**RE: Potential Change Order 0103
Collin County Justice Center - 3090**

Hunt Construction Group (Hunt) respectfully requests your review and approval of the attached Potential Change Order (PCO) number **0103** as titled: **Vanity Support Wall Modifications per RFI # 376 & 381**. This change is required because the contract documents did not require in-wall steel supports at all locations. After it was confirmed that supports were required at all locations, portions of the walls had to be removed, furred, and replaced to accommodate installation of the vanity support system as required. Cost to complete the work is as follows:

Request for Information 376

Request for Information 381

RFI 381

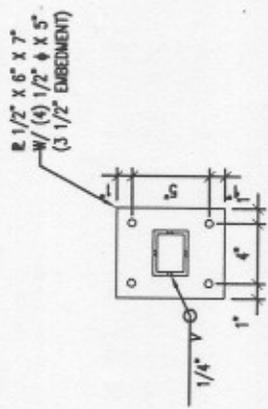
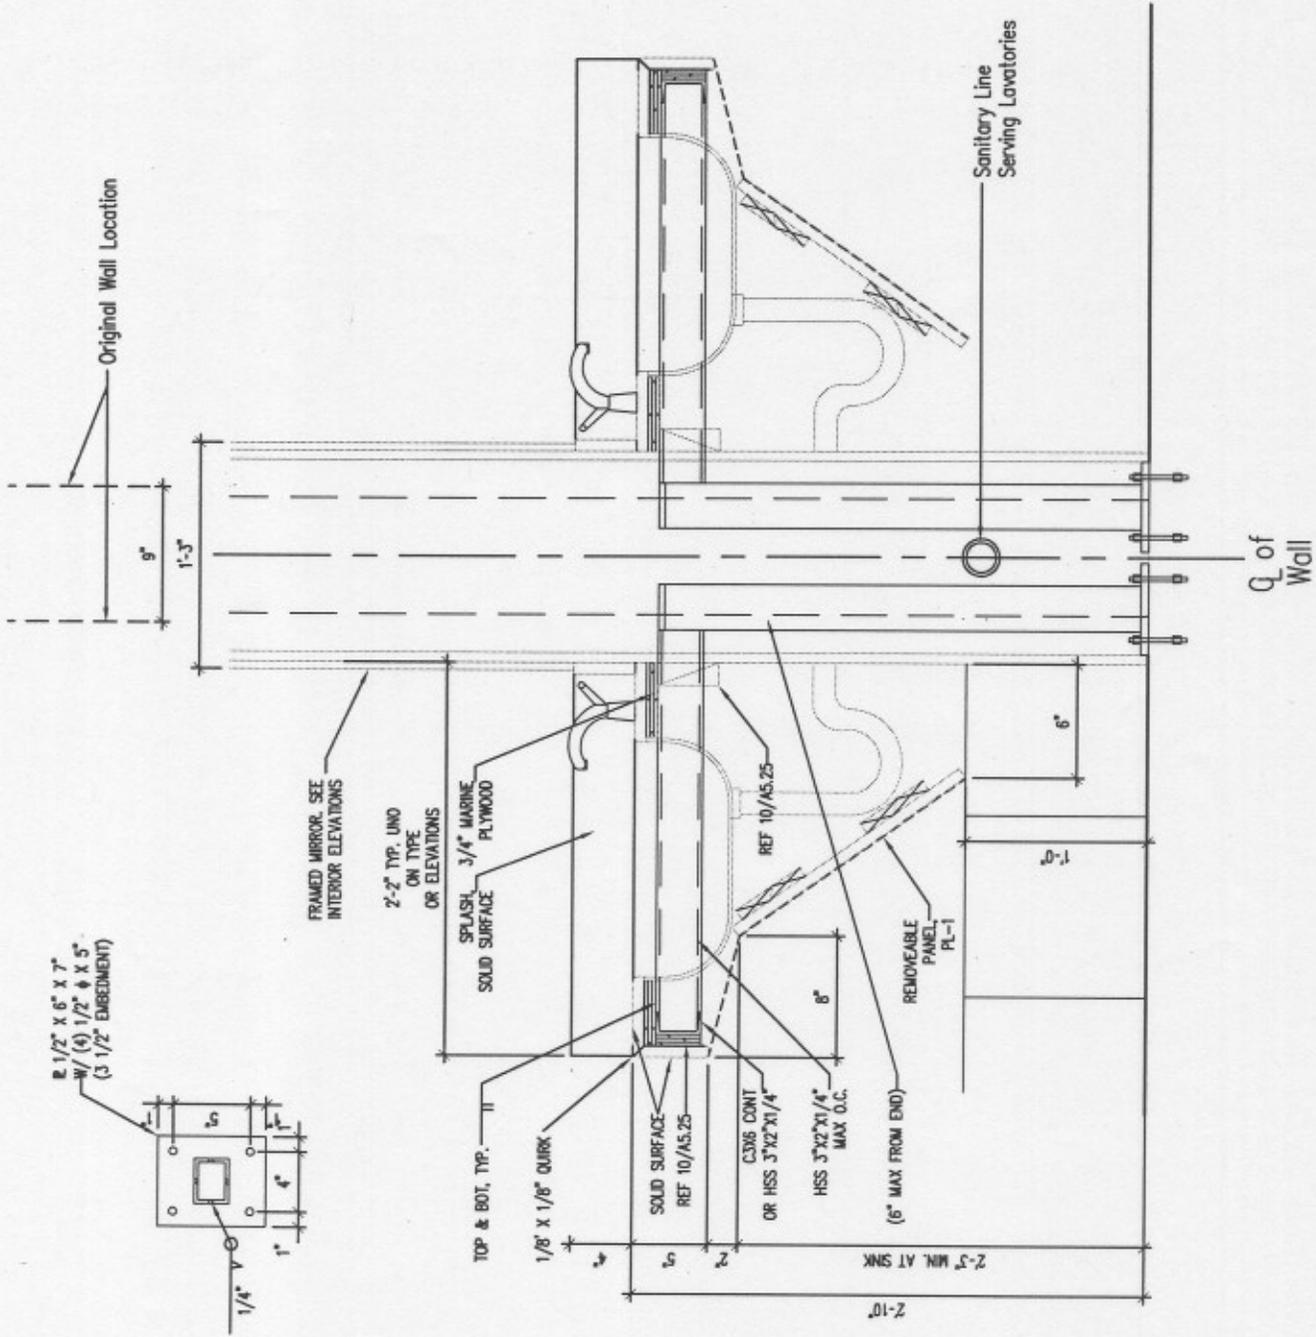
Gang restroom enlarged plan 2/A4.00 calls for a dimension of 9" at chase between lavatory counters. This is an insufficient amount of space to accommodate two (2) counter supports and a sanitary line as indicated in the attached sketch. This condition occurs at Restrooms: 00108, 00110, 10110, 10112, 10324, 10326, 20110, 20112, 20338, 20340, 30110, 30112, 30224, & 30226.

1. Per field conversations between John Reese, Eric Terry, & Shaune Hembrough, please confirm it is acceptable to furr the walls up to 3" at each restroom counter where this occurs.

1. The Contractor may, at his option, increase the plumbing chases per the Contractor's attached sketch in the Restrooms listed above. The walls perpendicular to the wet wall shall be checked to insure that there is sufficient room to allow for the installation of the recessed paper towel dispensers/disposals. Maintain a minimum of 1 1/2" clear (3" clear preferred) between: 1) the paper towel unit trim and the countertop, and 2) the paper towel unit trim and the end of the tile finish on the wall.
